# **Attachment D**

## ***AREA WALK-BY CHECKLISTS (AWCs)***

<b>Seismic Walkdown Submittal Report Review Comments and Resolutions Form</b>				
		Engineering Report Number GGNS-CS-12-00002	Rev. 0	Title Grand Gulf Nuclear Station Seismic Walkdown Submittal Report for Resolution of Fukushima Near-Term Task Force recommendation 2.3: Seismic		
Quality Related: <input type="checkbox"/> Yes <input checked="" type="checkbox"/> No		Special Notes or Instructions:				
Comment Number	Section/Page No.	Review Comment	Response/Resolution		Reviewer's Accept Initials	
1	SWC/AWC	None	N/A		N/A	
Reviewed By:		Doug Jones	Date	11/12/12	Resolved By:	Jason Pak / Chase Wharton
Site/Department:			Ph.		Date:	11/12/12

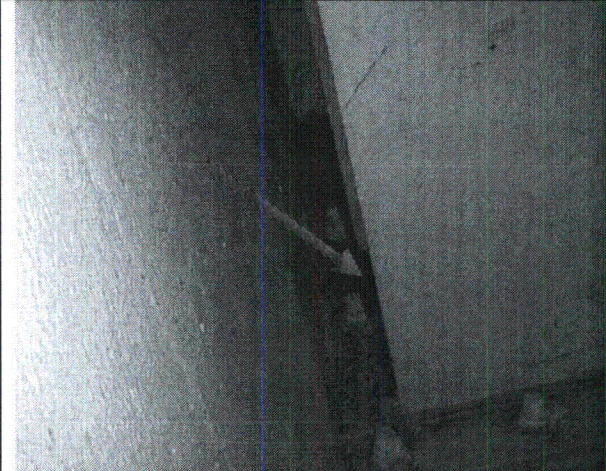
*Pry bar behind column. Temporary scaffold was identified in this area but did not create any seismic interaction issues. 18" line off RHR Heat exchanger A has a base plate that is not welded to embed plate for the support. The pipe support is for horizontal load of the pipe and allows the pipe to move in the vertical direction.*

**Note:** *Pry bar*

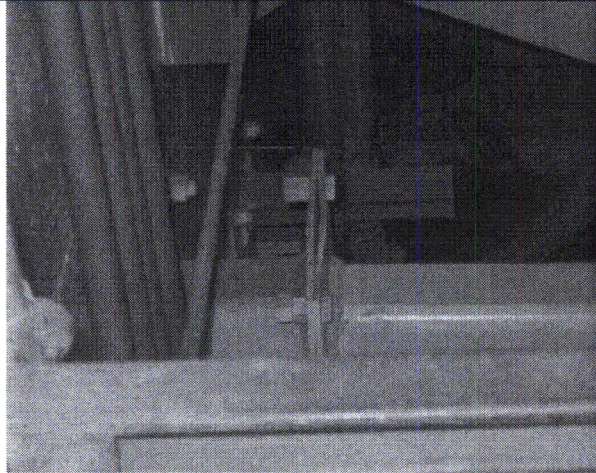
**Note:** *Bent base plate.*

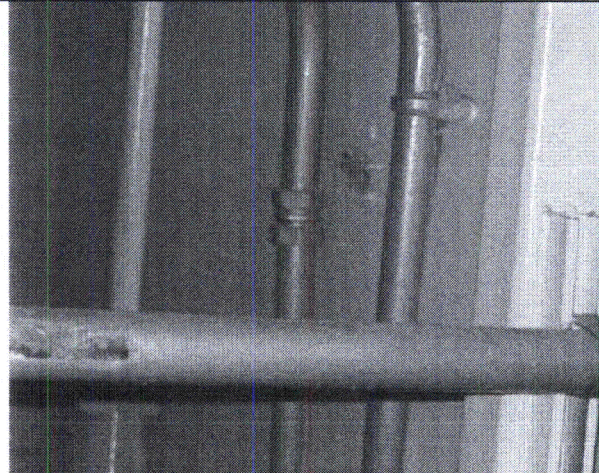
**Note:** *Broken conduit support.*

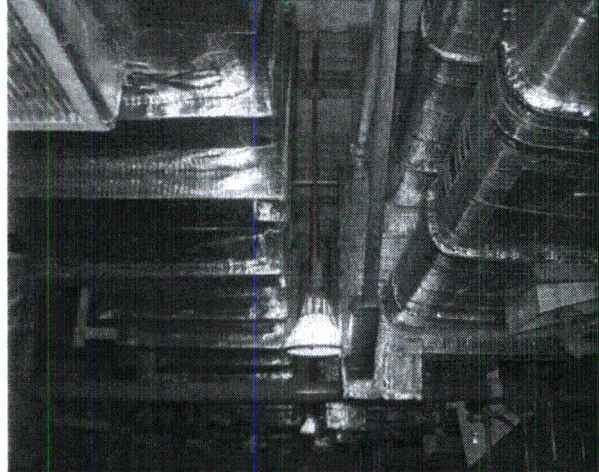
**Note:** *Potential contact, no adverse seismic condition*

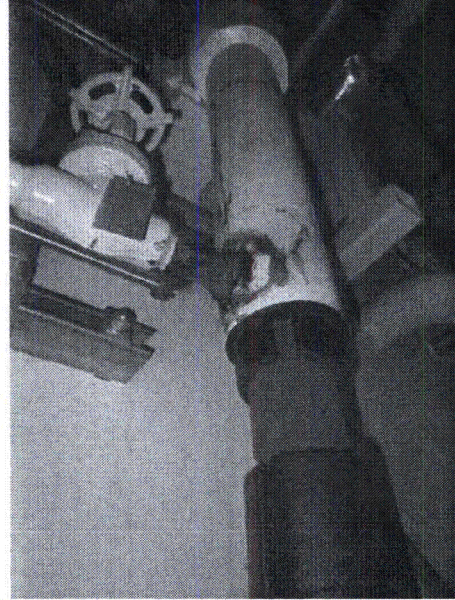
**Note:** *Surface corrosion on pipe*

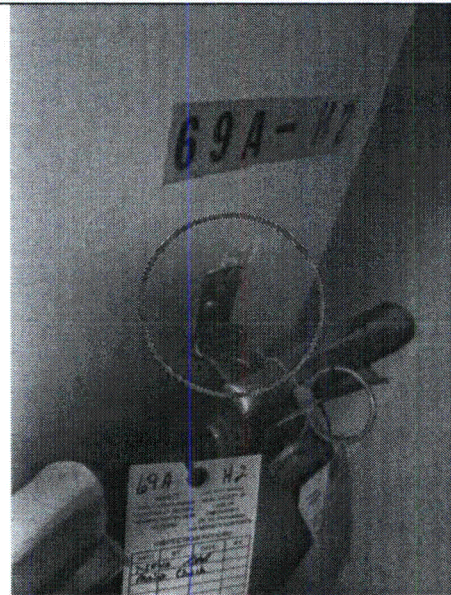
**Note:** Loose bracket on the wall supporting fire extinguisher

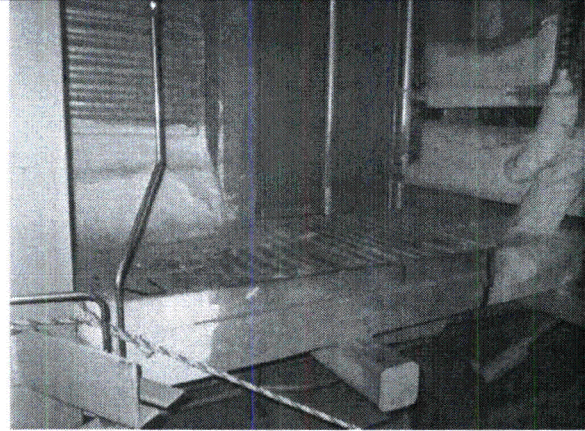
**Note:** *Rusted pipe*

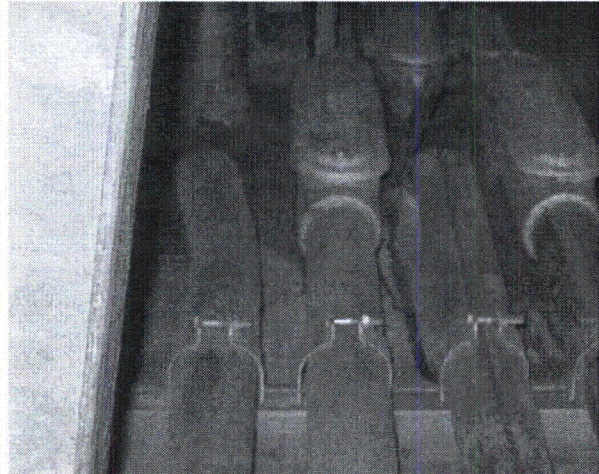
**Note:** *Exposed copper wire.*

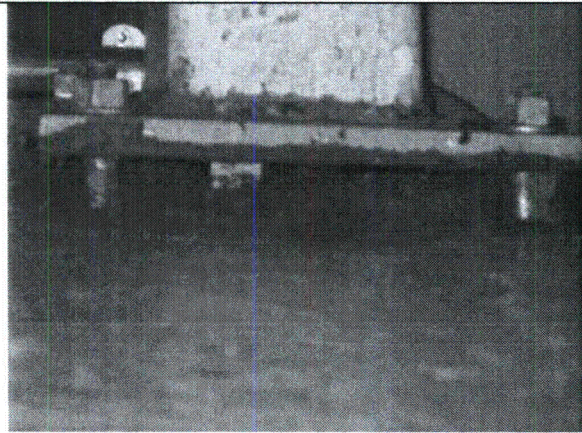
**Note:** *Degraded grout under the baseplate of pipe support*

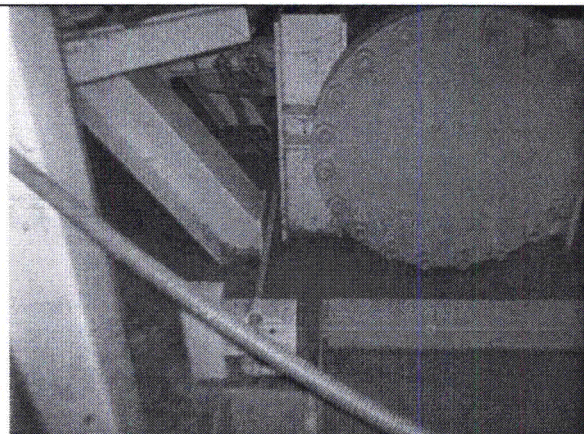
**Note:** Baseplate missing one anchor bolt, couldn't verify whether weld exists at that location.

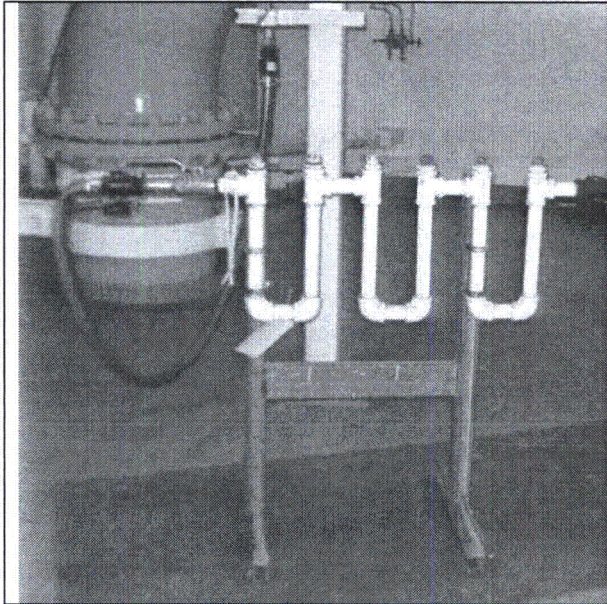
*There is a temporary corrosion coupon rack attached to plant equipment with a flexible line. This is located on a friction pad approximately 4.5' from any other plant equipment. The friction pad eliminates the concern of sliding during a seismic event. The coupon rack is less than 3' tall and will therefore not interact with other equipment if overturned.*

**Note:** *Temporary Coupon Rack*

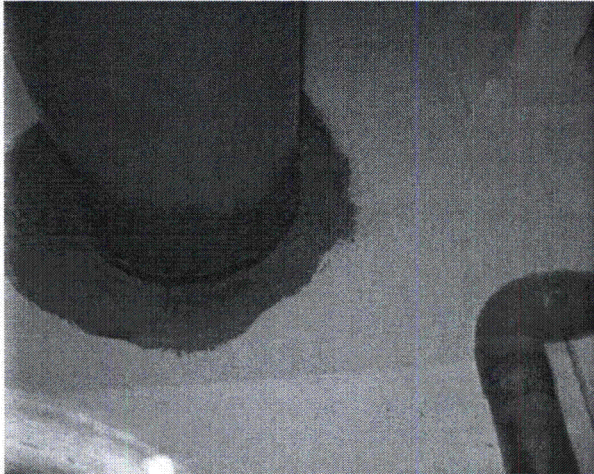
*Crack in penetratioin grout. Pen. # AP-58D. CR-GGN-2012-11083*

**Note:** *Visible crack in penetration grout.*
